DEVELOPMENT REVIEW COMMITTEE (DRC) COMMENT REPORT

PROJECT NAME: 101 Tower

CASE NUMBER: PLN-RACS-20020001

REQUEST: Site Plan Level II Review: Signage in the Downtown Regional Activity Center

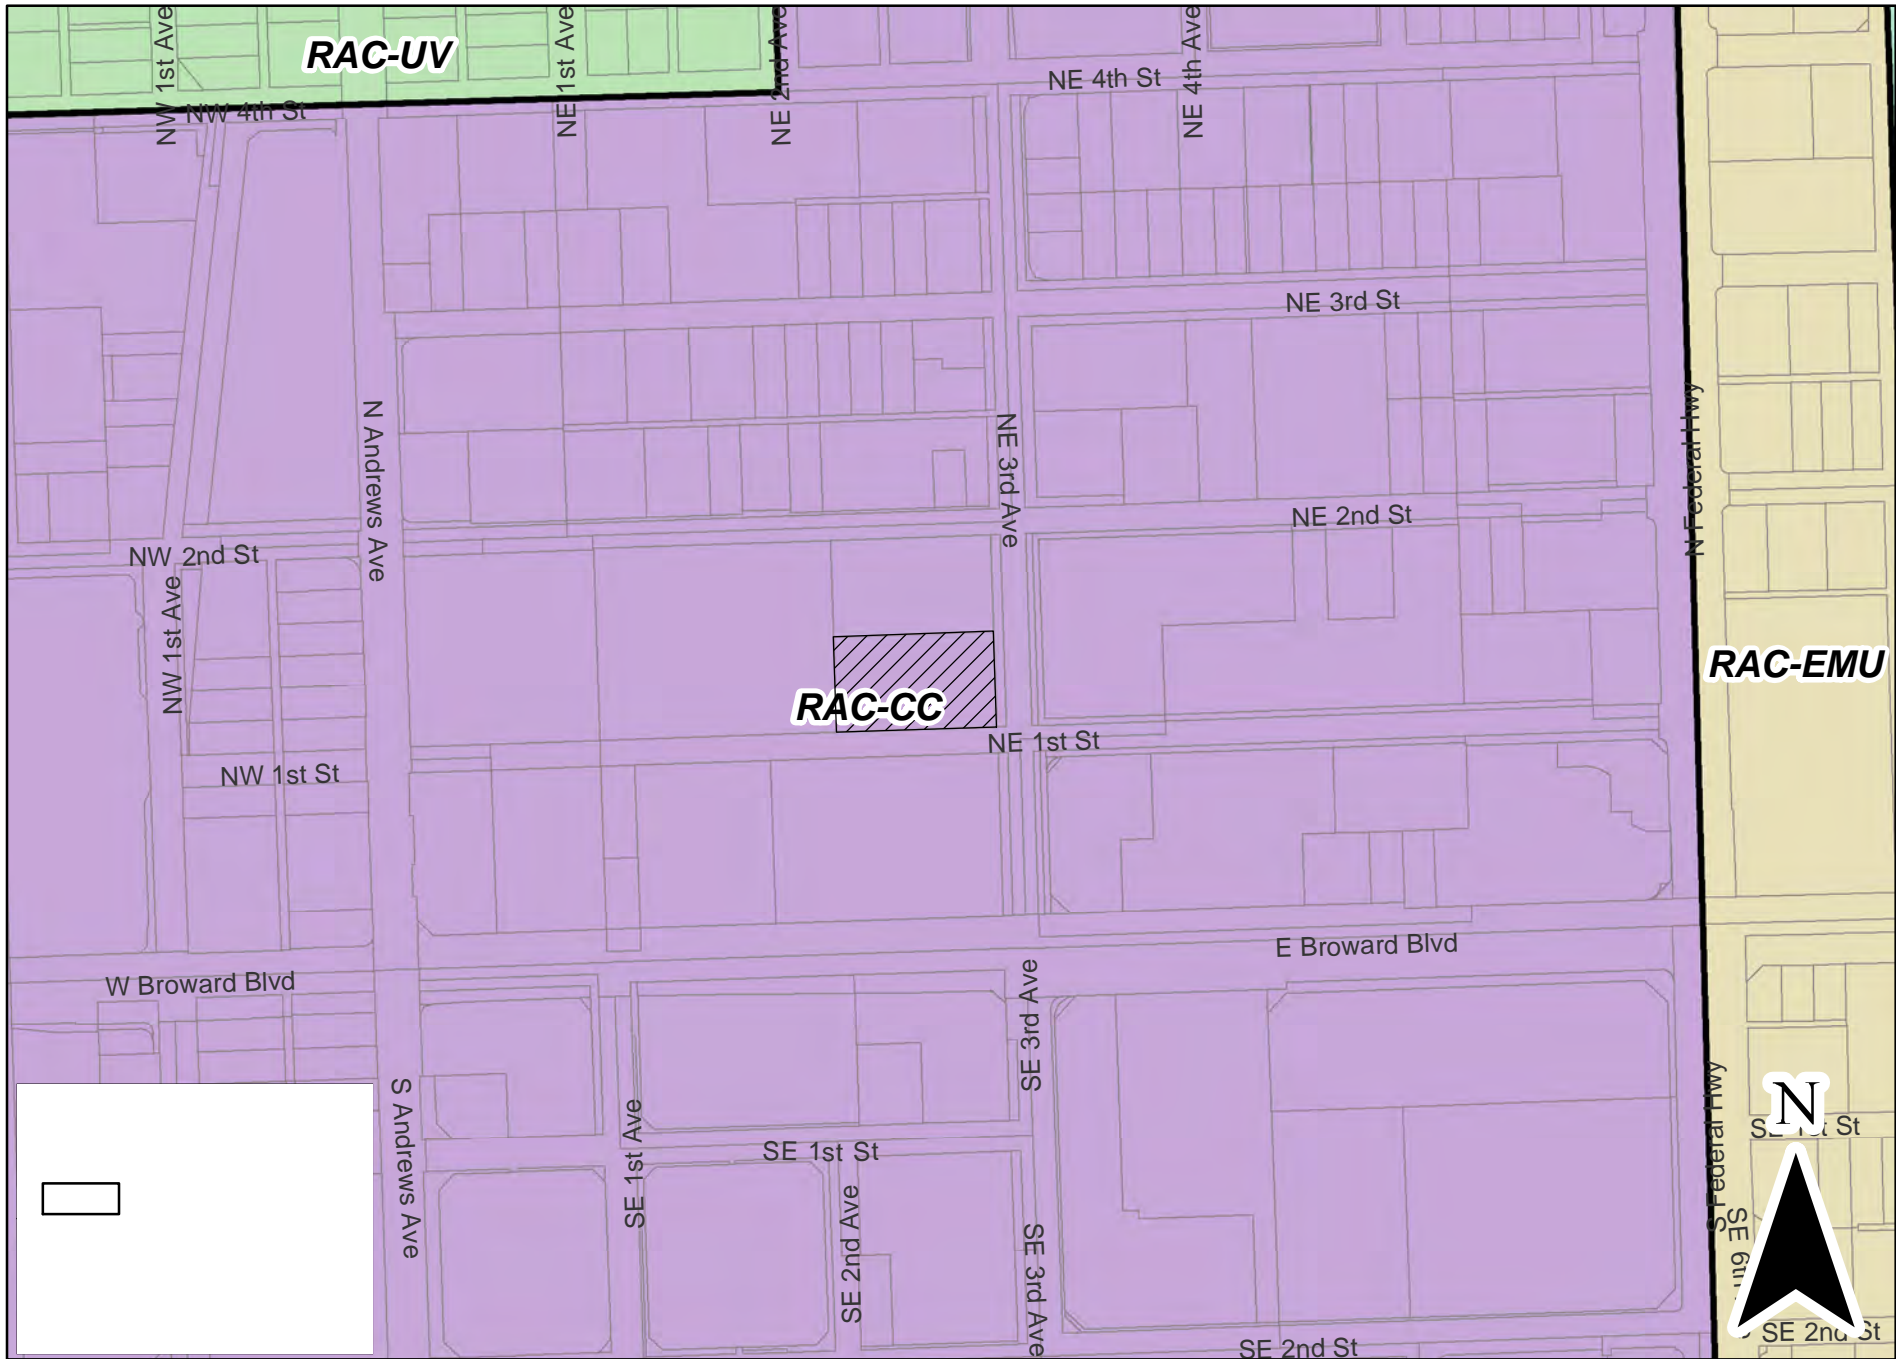
- 10) The Site Plan Level II Downtown sign review process allows applicants to request signage that may not be permitted by right via existing code. While it is intended to provide more flexibility, signs should generally align with the vision for Downtown. The Downtown Master Plan establishes a vision for a dense, active urban core focused on a strong human-scale relationship to the public realm and promotes design principles that foster a more walkable downtown with street level activity and comfortable pedestrian paths, plazas and open space.

Proposed signage should align with the overall intent of the Downtown Master Plan and should not create clutter, impede the pedestrian environment, or create visual obstructions in the public realm. For the reasons stated herein, monument signs are typically discouraged. However, other solutions may be more appropriate and may be approved on a case by case basis. For example, perpendicular blade signs, consistent in height and width, may provide great opportunities with clear visibility of the business location at the pedestrian level, while not impeding the pedestrian experience itself.

Oversized signs, numerous small signs, signs containing a clutter of letters or messages, all compete for the public's attention. Other common problems include quality of fabrication (materials such as plastic or vinyl are not high-quality materials), poor selection of typefaces and colors, illumination options, and placement, style, and sizing that bear no relation to the adjacent building's architecture. Signs on towers are also discouraged, as they distract from the tower design of buildings and have a negative impact the City's skyline.

Sign types and materials must be carefully selected to maintain durability and enhance the public realm throughout the Downtown. Respond to this comment by providing a written narrative outlining the design approach used for the proposed signs consistent with the Downtown Master Plan overall vision, as stated in the comment above.
